RE: **Grants Reclamation Project – DP-200 Renewal – Response to September 12, 2000 NMED Letter Transmitting Comments / Questions on Renewal Application**

**HOMESTAKE MINING COMPANY
Grants Reclamation Project
DP-200 Renewal**

**RESPONSES TO
NEW MEXICO ENVIRONMENT DEPARTMENT
REGARDING QUESTIONS / COMMENTS ON DP-200
RENEWAL APPLICATION
PER
NMED LETTER DATED SEPTEMBER 12, 2000**

C45

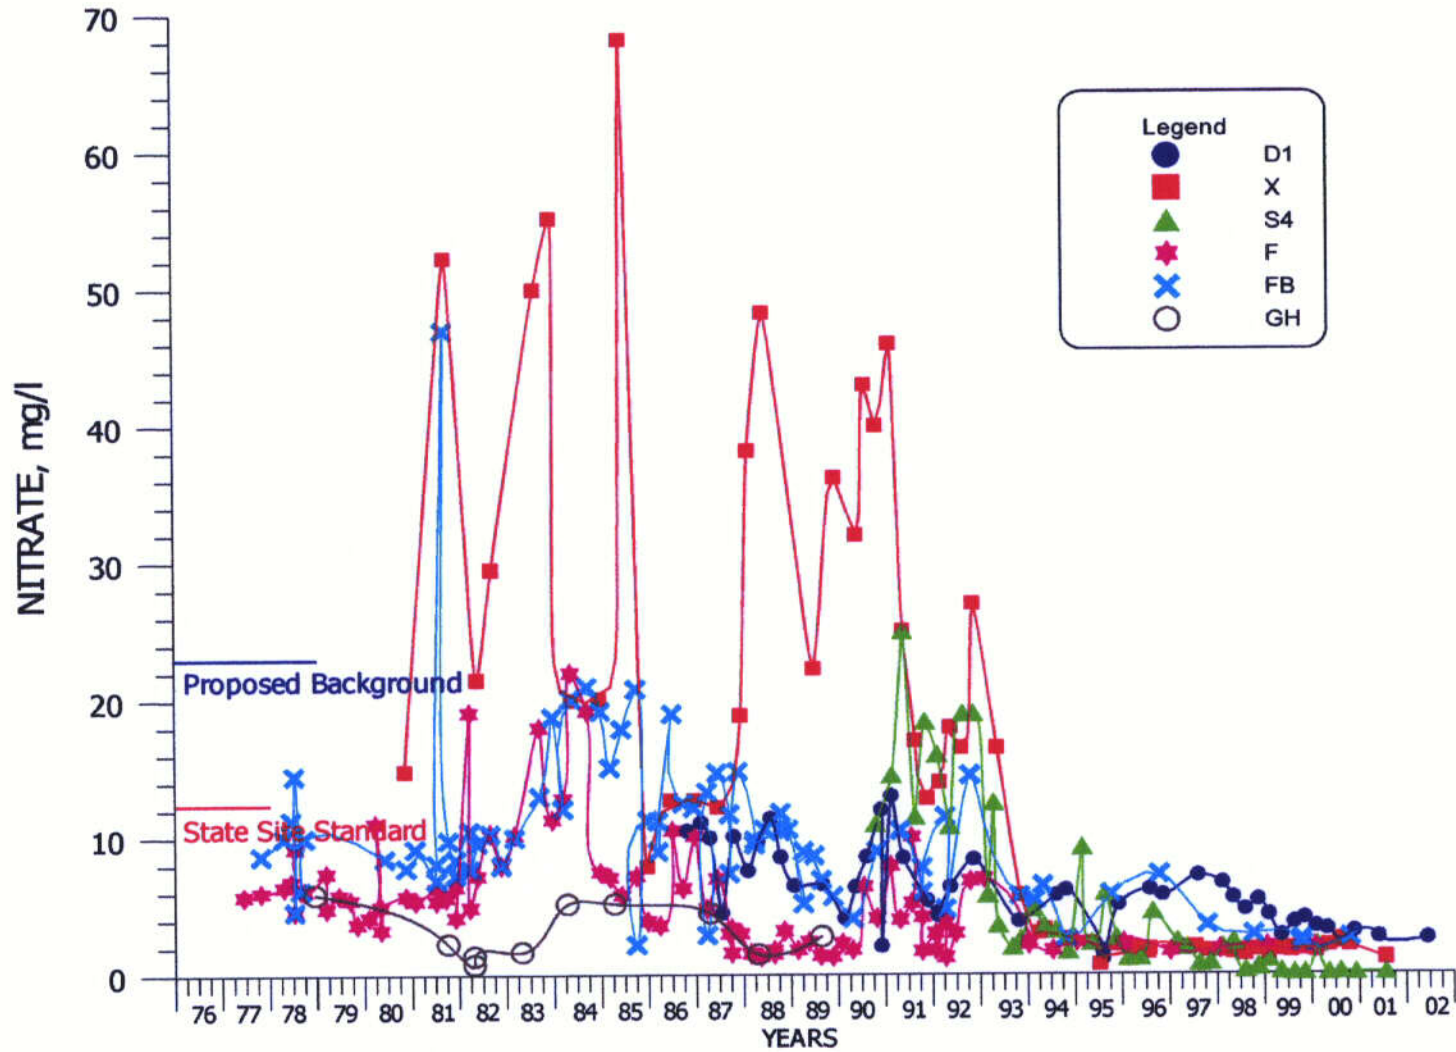
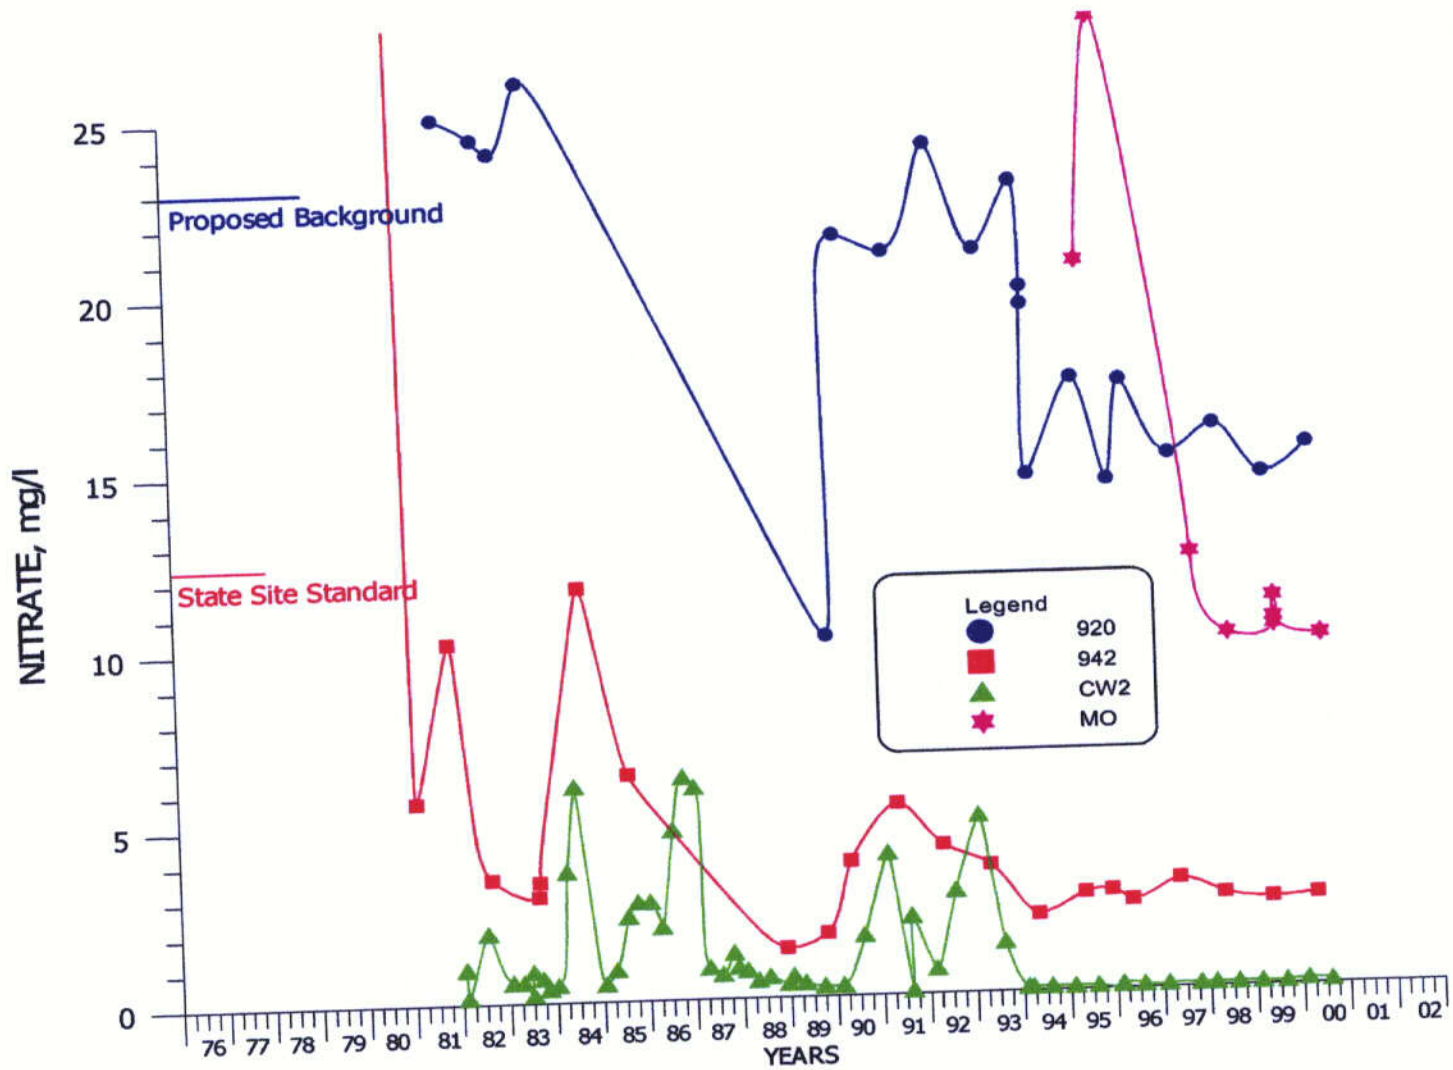
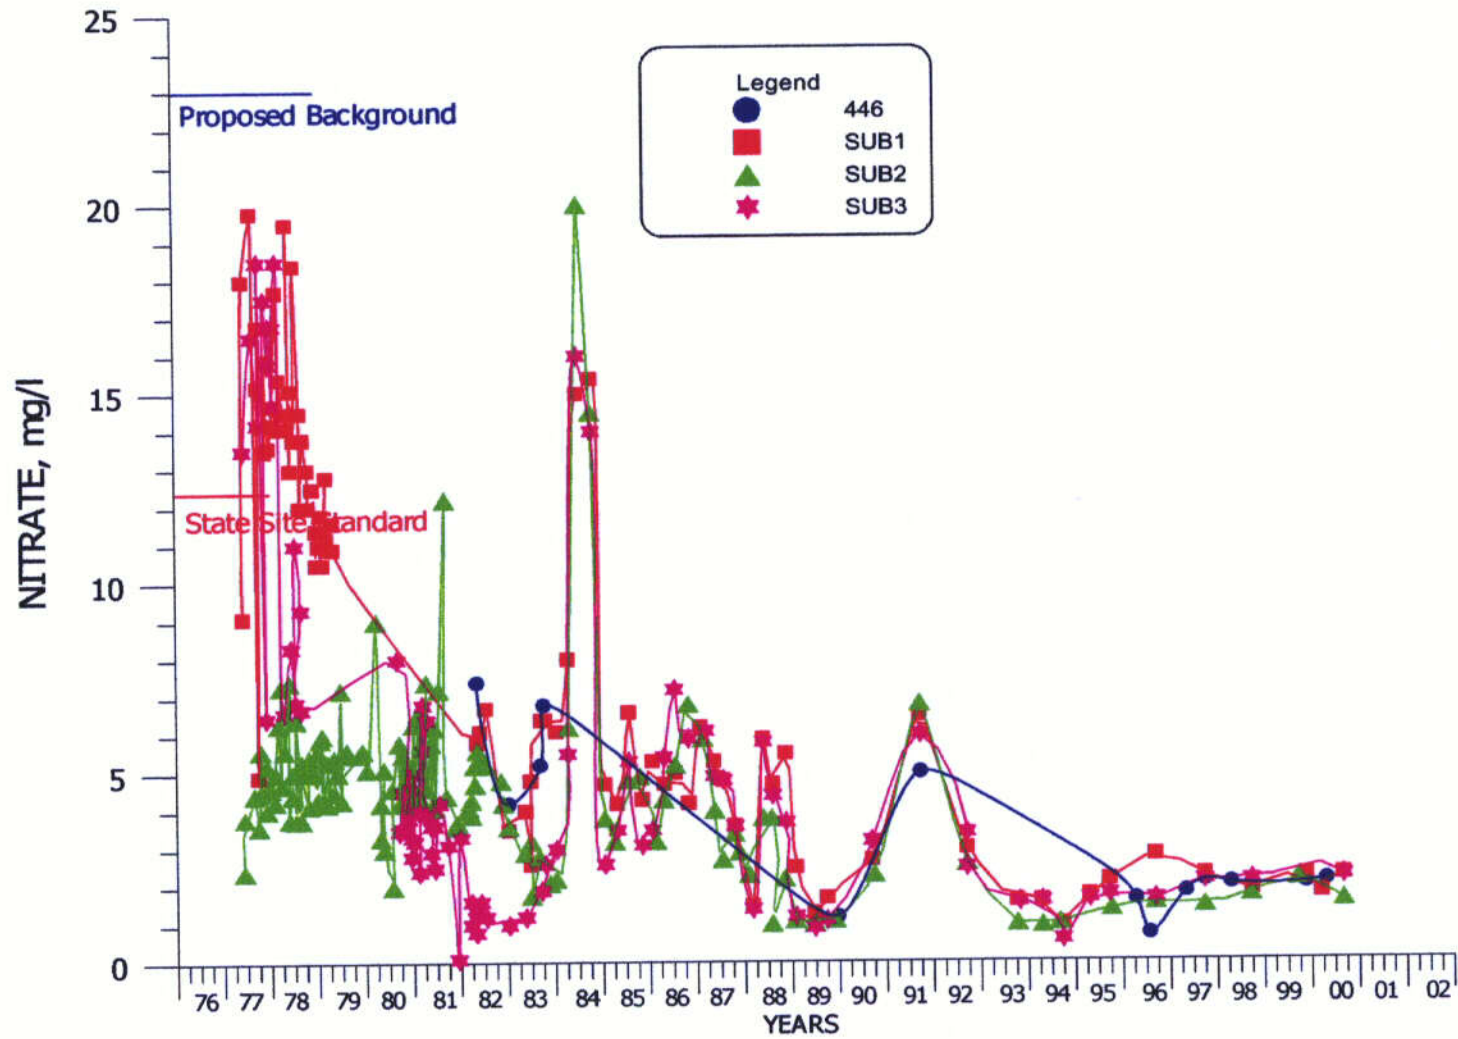
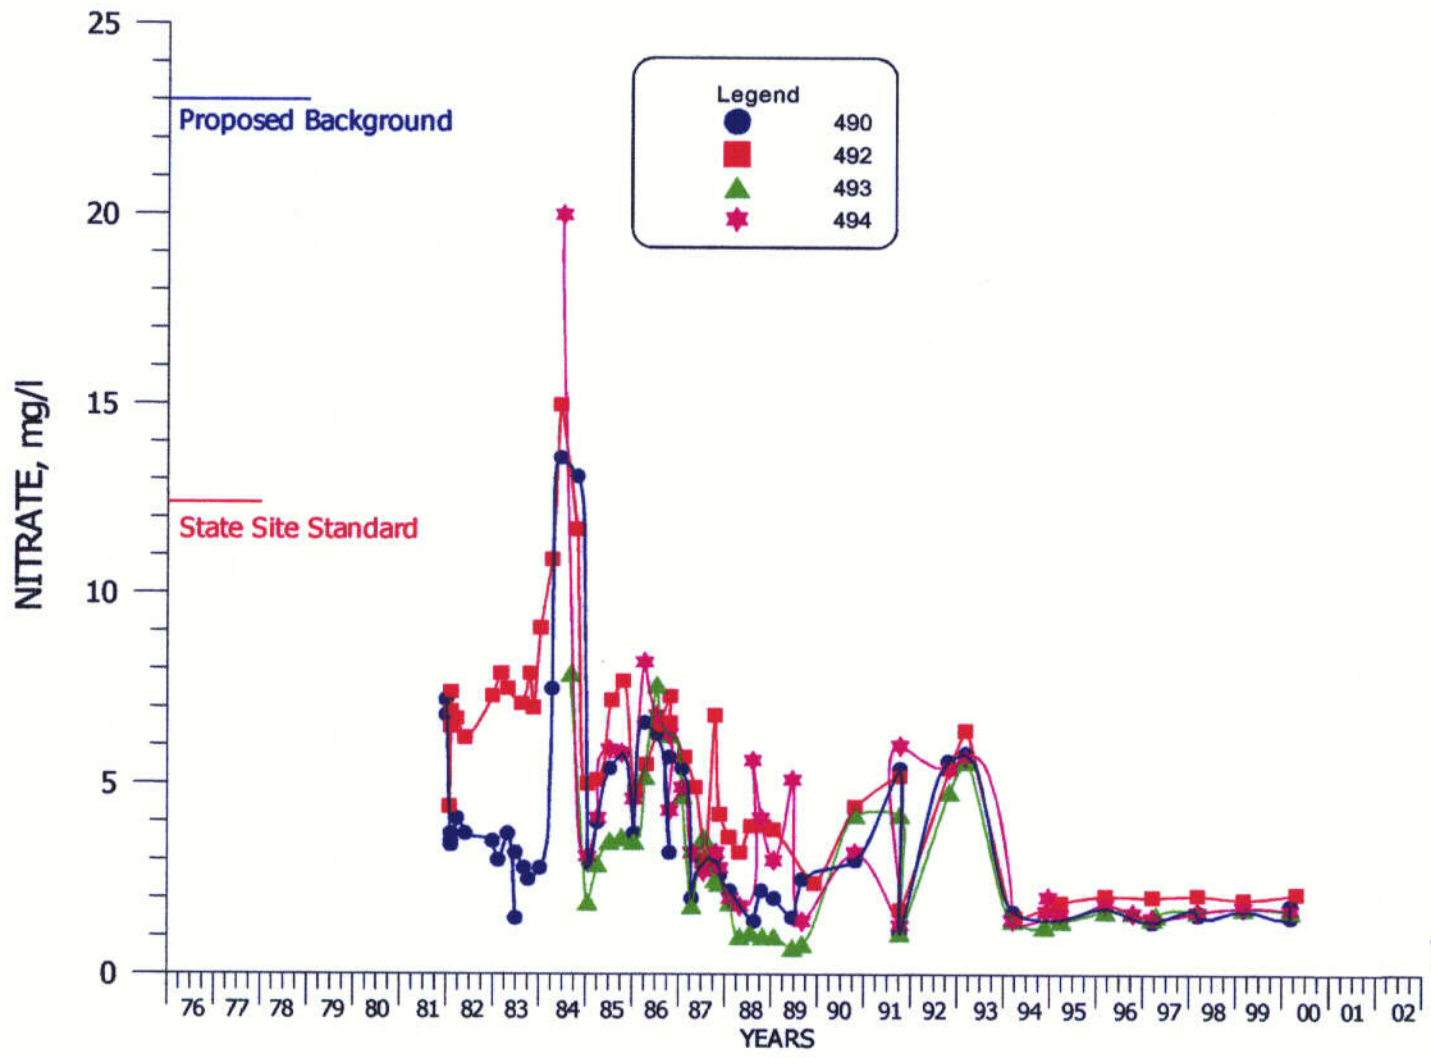
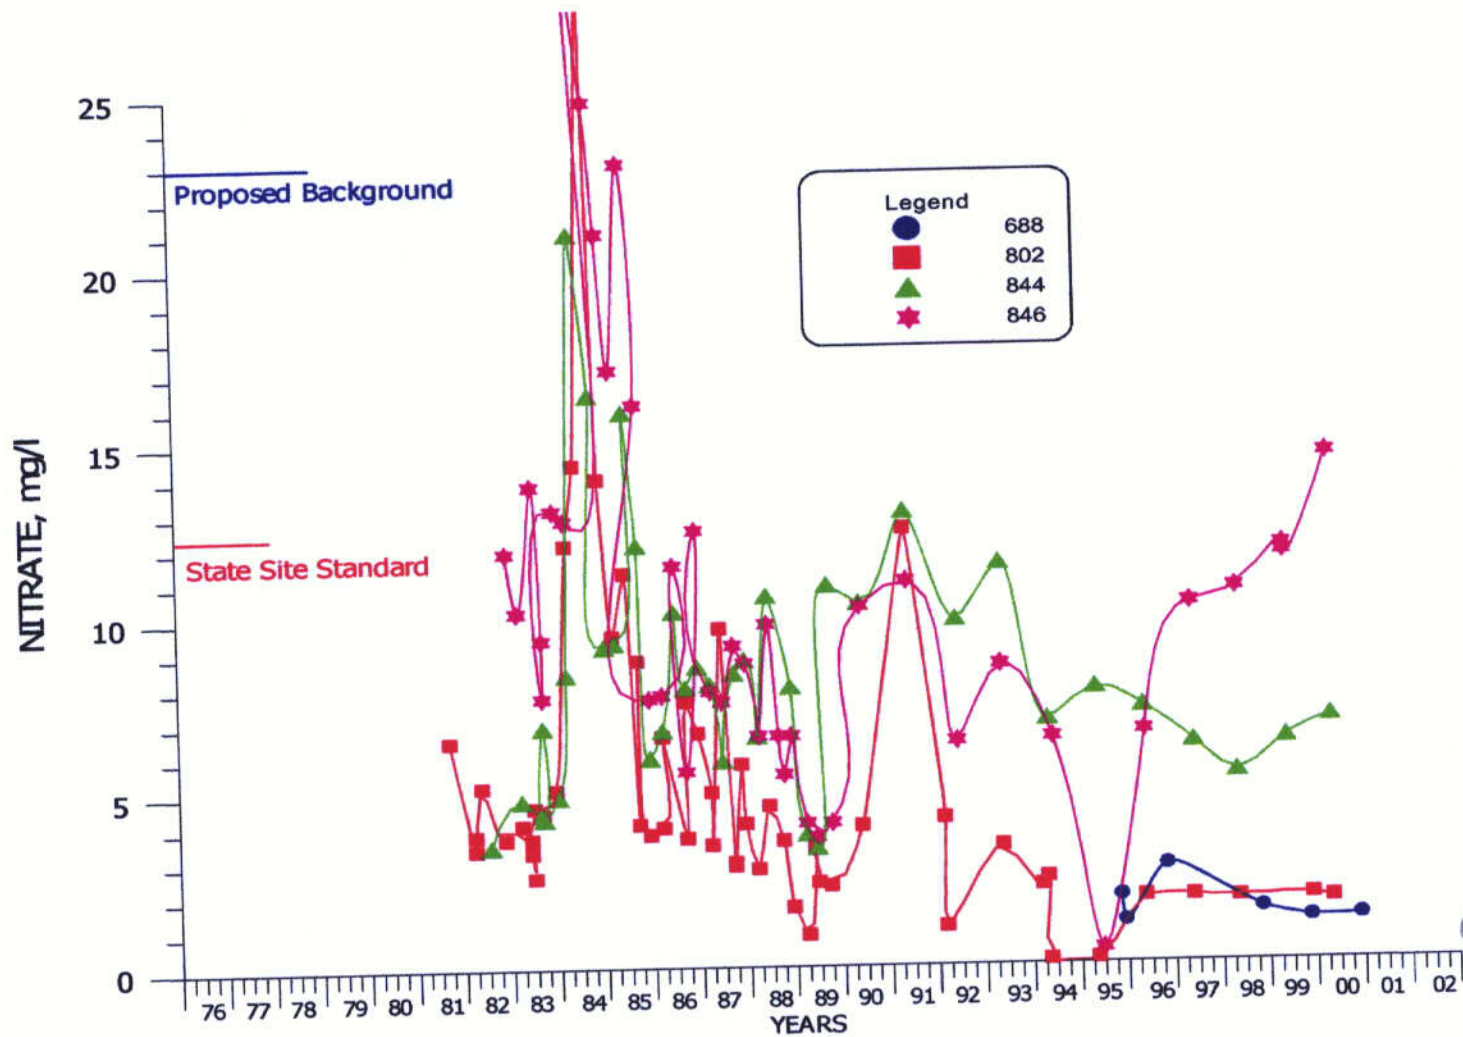
Comment: III.1.B. Graphs of Water-quality Data for the Table 2 Wells

Response: Plots for the routine monitoring wells from Table 2 of the NRC license are presented for sulfate, TDS, chloride, uranium, selenium, molybdenum and nitrate concentrations as Figures 15 through 49. The first group of wells for each of these constituents are presented for the three POC wells (Wells D1, X and S4) and

the initial figure also includes on site wells (Wells F, FB and GH). The following tabulation lists the figure numbers for each of the constituents:

CONSTITUENT	FIGURE NUMBER
SO4	15 – 19
TDS	20 – 24
Cl	25 – 29
U	30 – 34
Se	35 – 39
Mo	40 – 44
NO3	45 – 49

A few different vertical scales were required due to the large variations in parameter concentrations. The present State standard and the proposed background concentrations are presented on the plots.

FIGURE 50. LOCATIONS OF GEOLOGIC CROSS SECTIONS

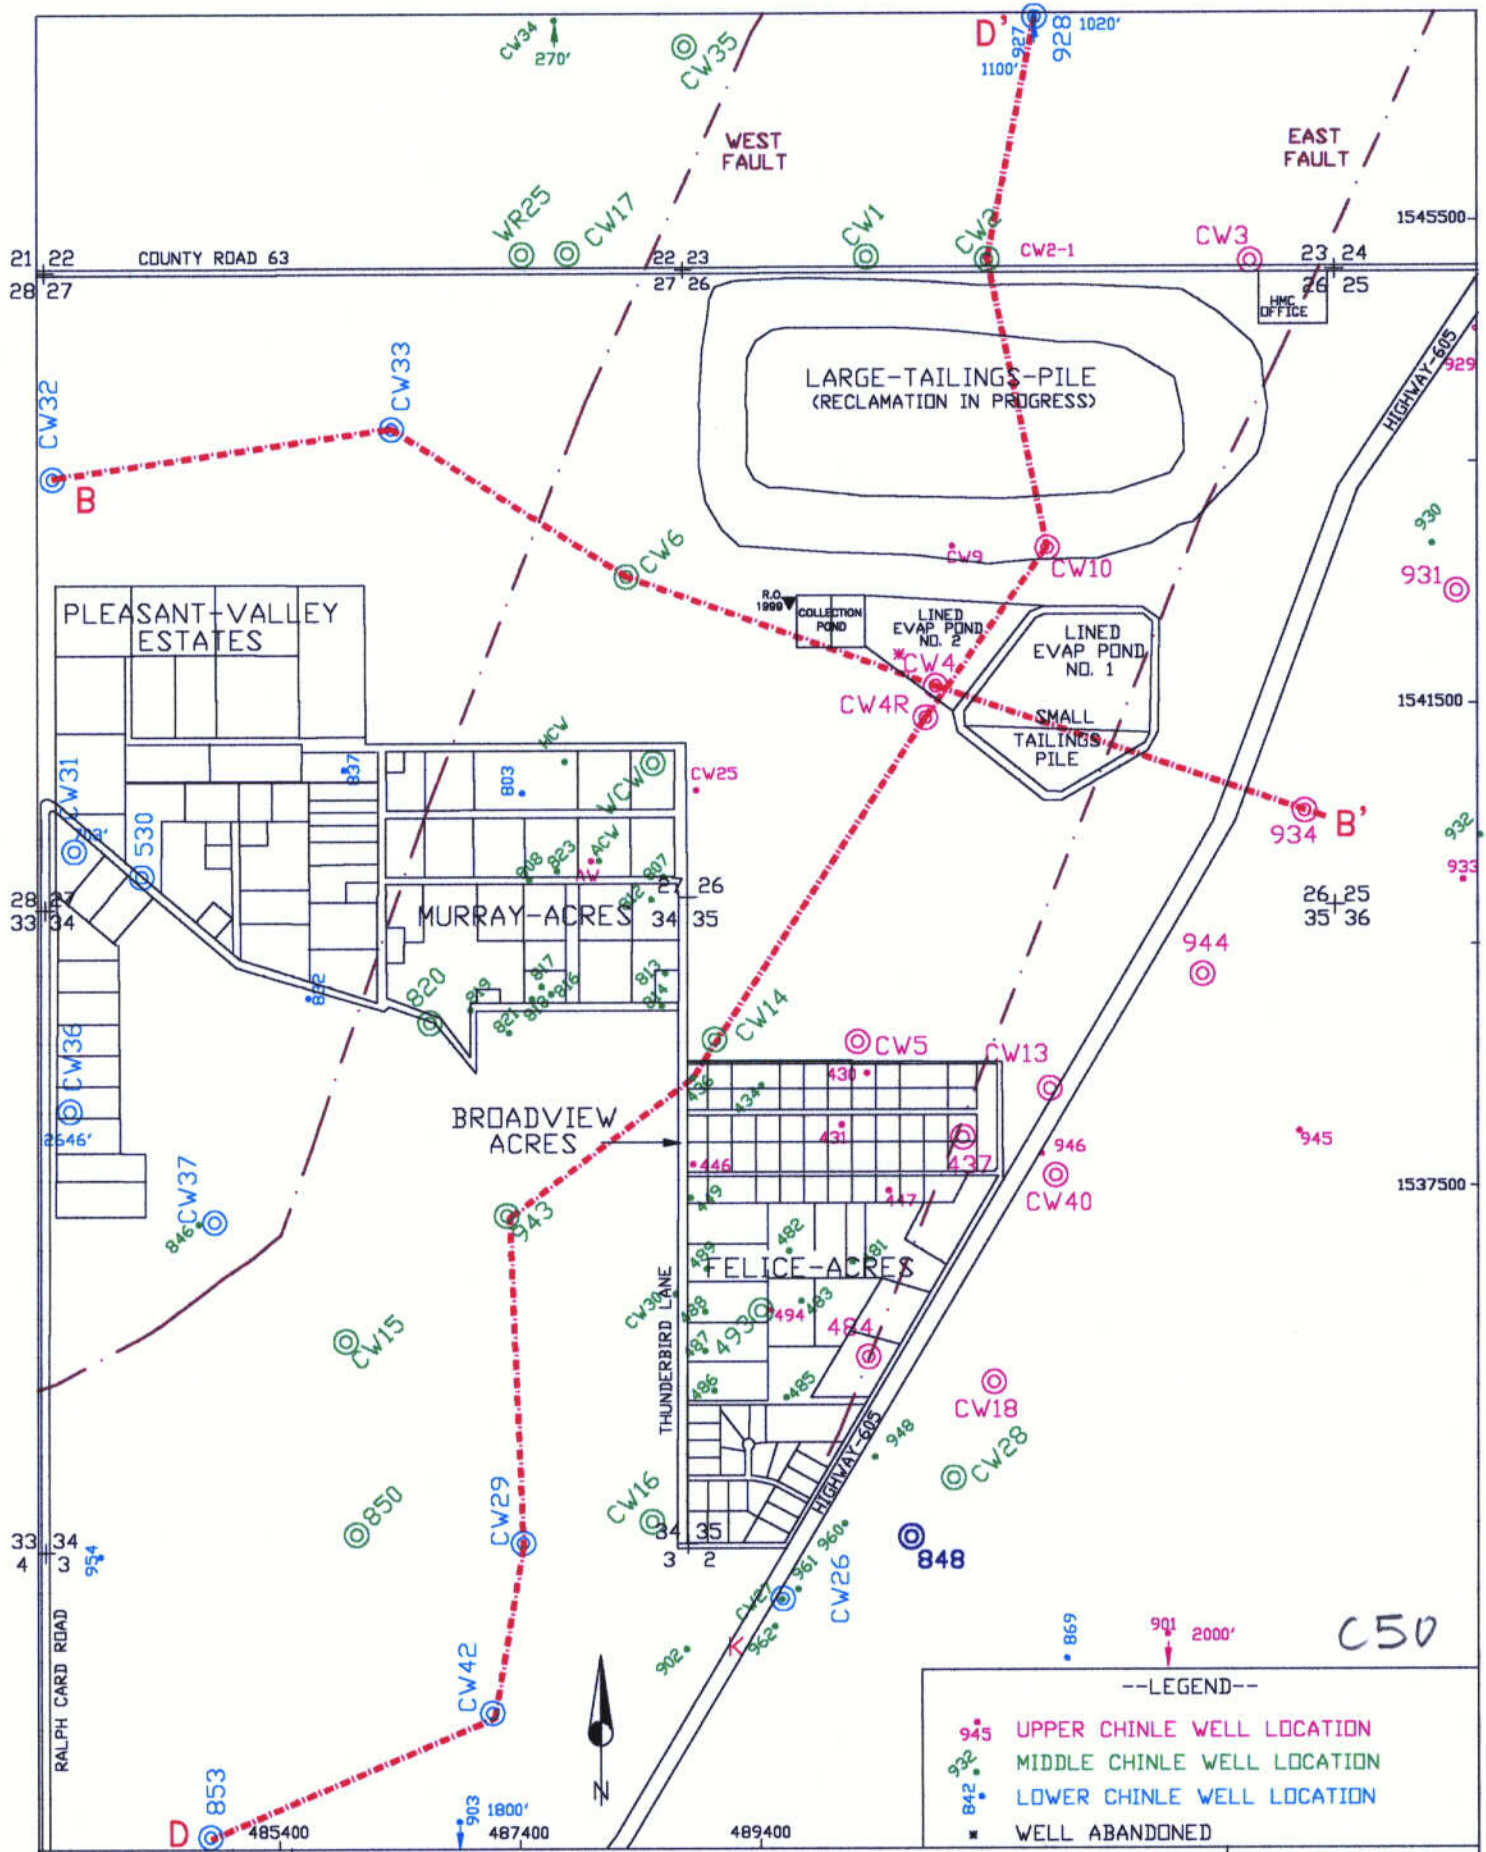
Comment: III.1.C. Updated Geologic Cross-Sections with Water Quality Concentrations

Responses: The geologic cross-sections were originally presented in the 1983 report for DP-200. Cross-sections B-B' and D-D' are presented in these responses to convey the geologic setting. These two cross-sections were put into ACAD with color patterns to portray water quality concentrations. Figure 50 shows the location of cross-sections B-B' and D-D'. Cross-section B-B' runs generally west to east just south of the Large Tailings pile while cross-section D-D' runs generally from the south to the north through the Large Tailings pile. The following list presents the drawing numbers for the two cross-sections for corresponding water-quality constituents.
